# FIVE ESTUARIES OFFSHORE WIND FARM

## 10.59.2 APPLICANT'S COMMENTS ON EAST ANGLIA TWO LIMITED'S DEADLINE 6 SUBMISSION

Application Reference:	EN010115
Document Number:	10.59.2
Revision:	A
Pursuant to:	Deadline 7
Eco-Doc Number:	005722929-01
Date:	March 2025

FIGURE 1. A) LEFT - WIND ROSE PRESENTED BY EA2, B) RIGHT – EXAMPLE WTG POWER CURVE

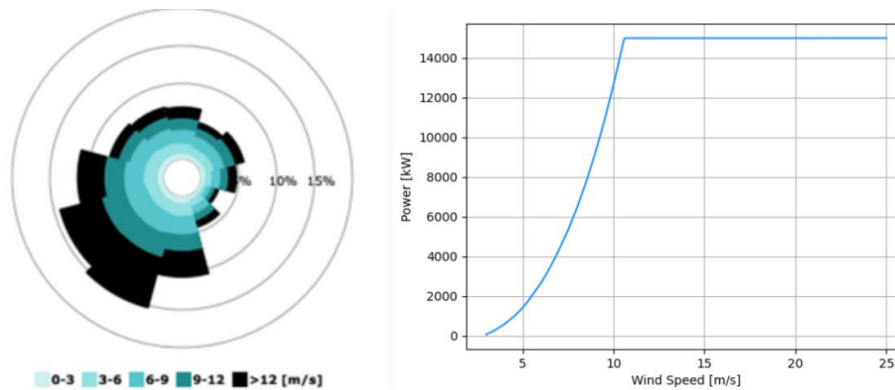
2.3.6 To expand upon the point in paragraph 2.3.4 The Applicant refers to the 'wind rose' presented in the assessment; repeated below in Figure 1 for convenience. This shows the prevailing direction of the wind as being from the south west and going to the north east. When considering the wake effects of neighbouring wind farms it is important to not only consider the wakes caused by wind farms "up wind" in the prevailing direction, the impact of wakes caused by wind farms "up wind" in the non-prevailing direction must also be considered as these impacts can be of a similar magnitude.

2.3.7 The reason for this is because the energy output generated by WTGs is not a linear correlation with wind speed; the WTG power curve as shown in Figure 1 b) must be considered.

Rated wind speed is the speed at which the turbine is at its maximum generating capacity. When the wind is above this speed it does not generate any more energy as the wind speed increases; below this speed there is a curved gradient whereby changes in wind speed have a significant impact on WTG output.

- 2.3.8 This means that although turbines will be creating wakes at speeds above rated wind speed, if the wind at the “waked” turbines remains above the speed associated with rated power then there will be a negligible impact on the yield.

- 2.3.9 Conversely wakes being created when the wind is blowing at or below rated power that cause, the wind speed at the “waked” turbines there will be a significant loss of power generated by the “waked” turbines.

- 2.3.10 In the case of the wind rose presented by East Anglia Two although it may appear that there is strong prevailing wind from the south west, the impact on yield does not directly correlate to this and the impact of East Anglia Two on the Proposed Development when the wind is blowing in the non-prevailing direction must also be considered.

FIGURE 2. WIND FARMS INCLUDED IN THE EAST ANGLIA TWO WAKE ASSESSMENT

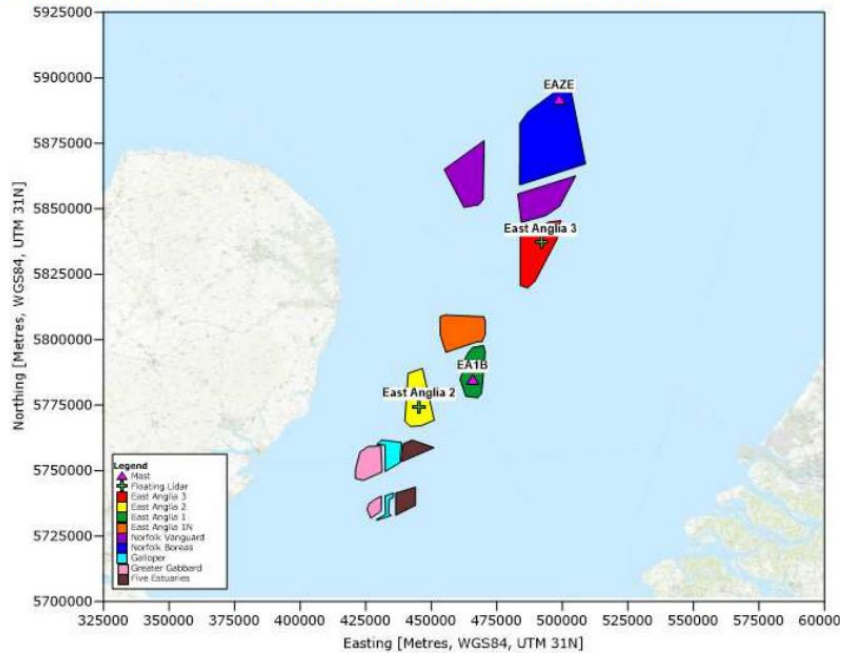
- 2.3.12 The Applicant notes that East Anglia Two have provided “wind farm layouts, turbine types, hub heights, turbine power curves and thrust curves for East Anglia 2 wind farm, and for all other neighbouring wind farms, as shown in Figure 1.” This Figure 1 provided by East Anglia Two is shown below in Figure 2.

FIGURE 3. WIND FARMS “UP WIND” IN THE PREVAILING DIRECTION THAT ARE NOT INCLUDED IN THE EAST ANGLIA TWO WAKE ASSESSMENT

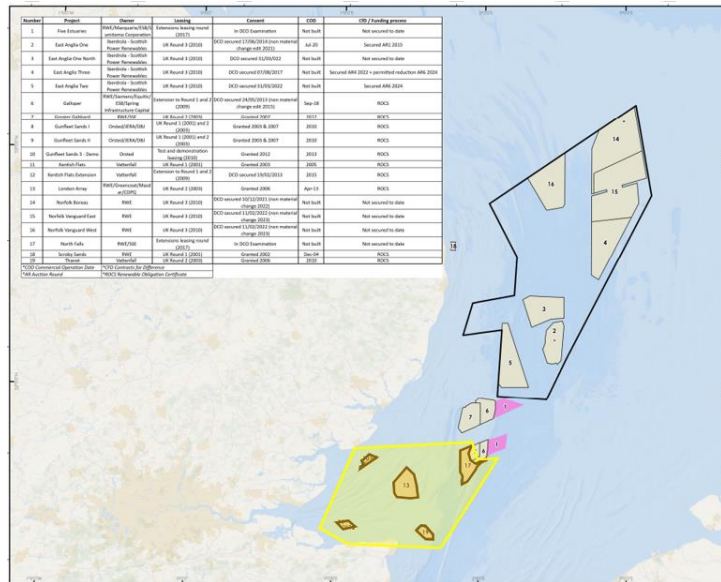
2.3.13 None of the operational or proposed wind farms “up wind” in the prevailing wind direction have been modelled in the assessment. These wind farms in the “up wind” direction are highlighted in Figure 3.

2.3.14 The exclusion of these wind farms means that wakes and blockage effect being caused by these wind farms when the wind is blowing in the prevailing direction “up wind” from Five Estuaries are not accounted for in the assessment provided by East Anglia Two Limited.

2.3.15 This means that the quantified impact being calculated by East Anglia Two wake assessment will be therefore highly overestimate the impact of Five Estuaries wakes on East Anglia Two.

**FIGURE 4. NORMAL DISTRIBUTION SHOWING THE WAKE LOSS UNCERTAINTY**

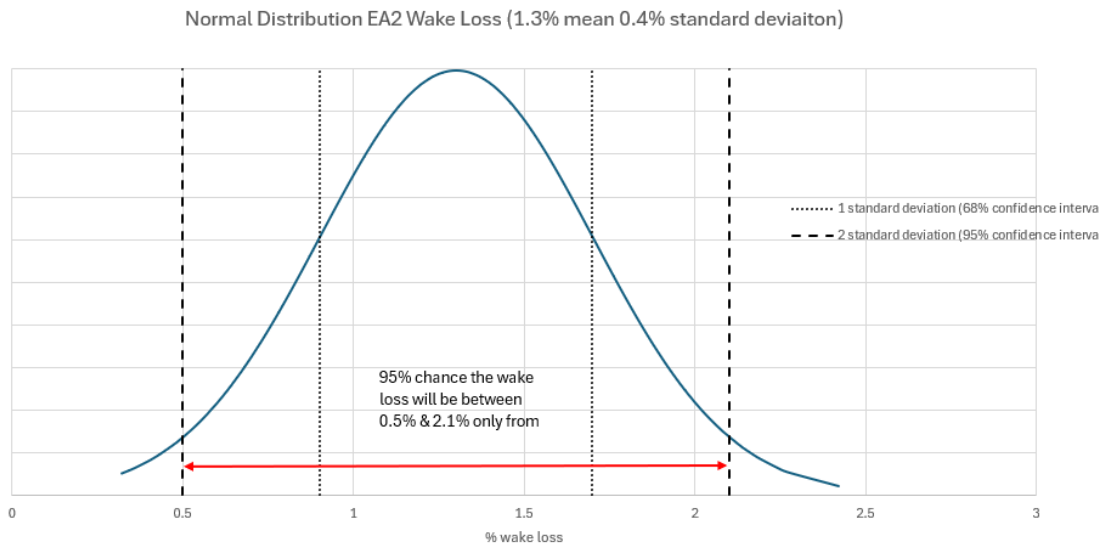
2.3.36 The Applicant notes that the “uncertainty” presented in the report is actually the standard deviation.

2.3.37 It is more appropriate to reflect uncertainty through the use of estimation with confidence levels. A normal distribution graph is shown in Figure 4 below. This shows that with a mean of 1.3% and a standard deviation of 0.4% there is a 95% chance that the value of wake loss will be between 0.5 and 2.1%; or there is a 68% chance that the value of wake loss will be between 0.9 and 1.7%.

- 2.3.38 Putting this in context the range in the 95% confidence interval is greater than the central estimate of wake loss.
- 2.3.39 This level of uncertainty is before the assumption uncertainty is accounted for which is also noted as having a high impact.
